Work Order ID 119585

Item Name: Crosstube Turning Detail

DART AEROSPACE LTD		Work Order:	119585
Description: Crosstube Assembly (205/212/412 High Fwd)		Part Number:	D212-664-141
Inspection Dwg: D212-664-141 Rev: D		Page 1 of 2

DRAWING NO. D212-664-141	TITLE XTUBE ASSY (205/212/412 HI FWD)	REV. D	DART AEROSPACE LTD ENGINEERING ORDER		D.E.O. NO. D212-664-141-D-1	SHEET NO. SHEET 1 OF 2	SCALE NTS
DRAWN	CHECKED	MP	MFG. APPR.	APPROVED	MP	DE APPR.	
DATE 11.04.07	DATE 11.07.11		DATE 11.04.12	DATE 11/04/12		DATE 11.04.12

D212-664-141/-141B
ASSEMBLY DETAIL

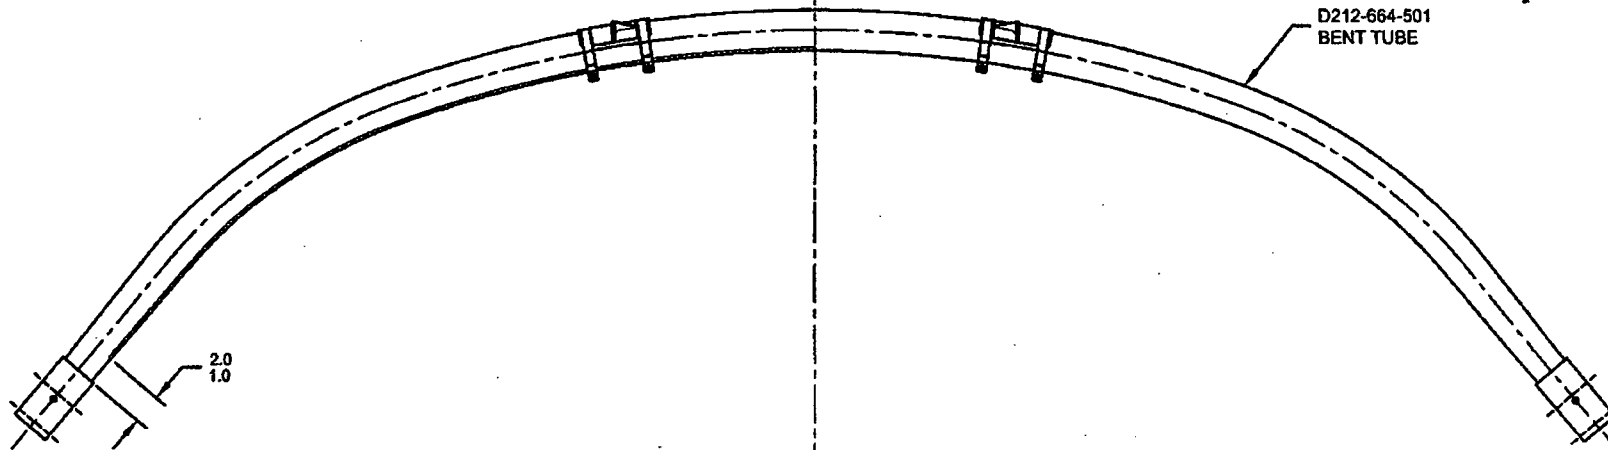
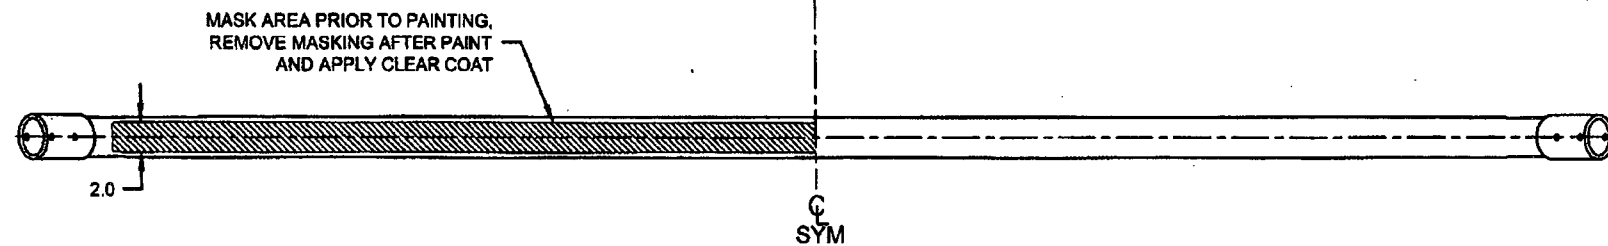
PURPOSE:

ADD AN INSPECTION WINDOW TO UNDERSIDE OF CROSSTUBE.

NOTES 2 OF SHEET 1 IS AMENDED AS FOLLOWS:

- 2) FINISH: CHEMICAL CONVERSION COAT PER DART QSI 005 4.1
PRIME INSIDE AND OUTSIDE PER DART QSI 005 4.2
MASK UNDERSIDE OF CROSSTUBE AS SHOWN (HATCHED AREA) AND
PAINT OUTSIDE PER DART QSI 005 4.2
REMOVE MASKING AND APPLY CLEAR COAT
